This Addendum is required to add Environmental Permit Application, add a new special provision, add a new contract item, revise a contract item, delete contract items and revise plan sheets.

REHABILITATION OF METRO-NORTH RAILROAD BRIDGE NO. 03948R OVER
SOUND BEACH AVENUE AND BRIDGE NO. 03955R OVER TOMAC AVENUE

FEDERAL AID PROJECT NO'S. CT-05-0107 AND CT-90-X510
STATE PROJECT NO. 301-092

ADDENDUM NO. 3

TOWN: GREENWICH	PROJECT NO. 301-092
DRAWING TITLE: SEDIMENTATION AND EROSION CONTROL PLAN	DRAWING NO. C-10
	SHEET NO. 11.12.A3

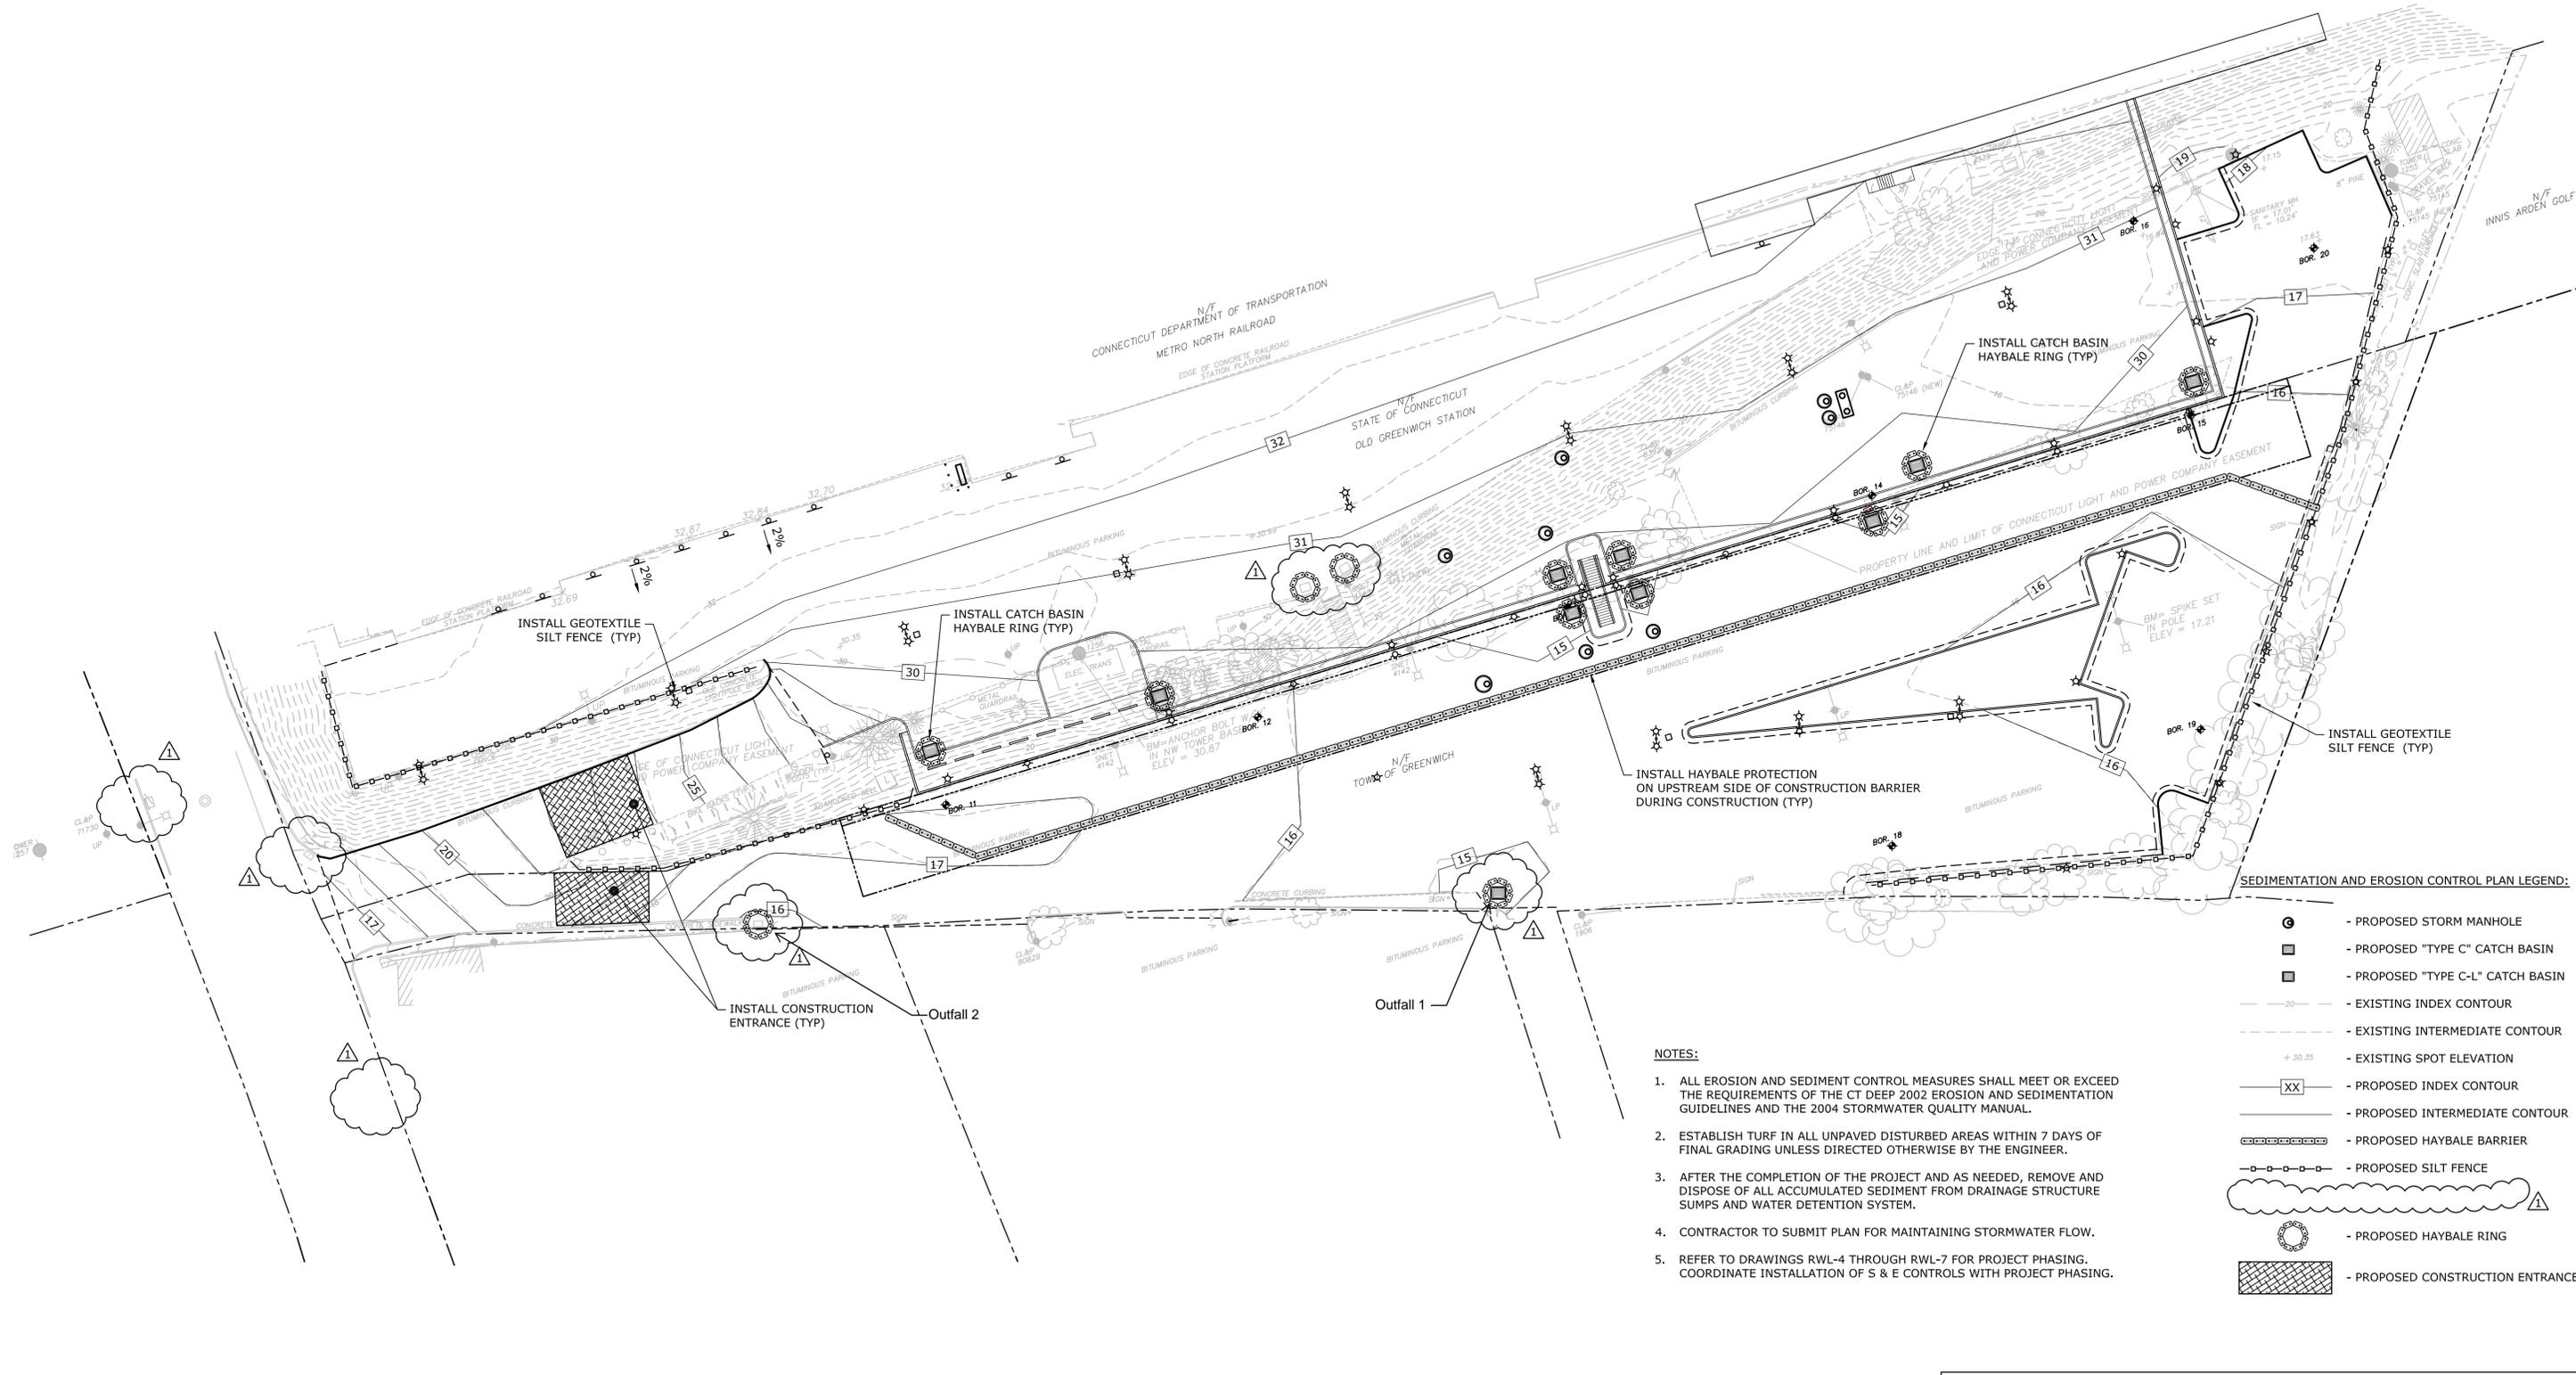
The following Plan Sheets are hereby deleted and replaced with the like-numbered Plan Sheets:

- 02.01.A3
- 05.31.A3
- 05.32.A3
- 06.04.A3
- 06.05.A3
- 11.12.A3
- 11.13.A3
